SERVICE INFORMATION BULLETIN

APPLICABILITY: **NUMBER:** 12-271-19 2015-19MY WRX

SUBJECT: Rear Bumper Face Side Mounting Brackets-

Design Change

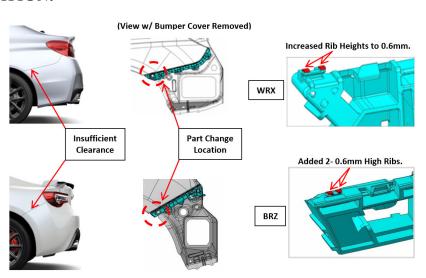
This Service Information Bulletin announces a design change made to the rear bumper cover side mounting brackets. These new brackets provide increased clearance between the edges of the bumper cover and the corresponding quarter panels. This change will prevent them from contacting each other and possibly damaging their painted surfaces.
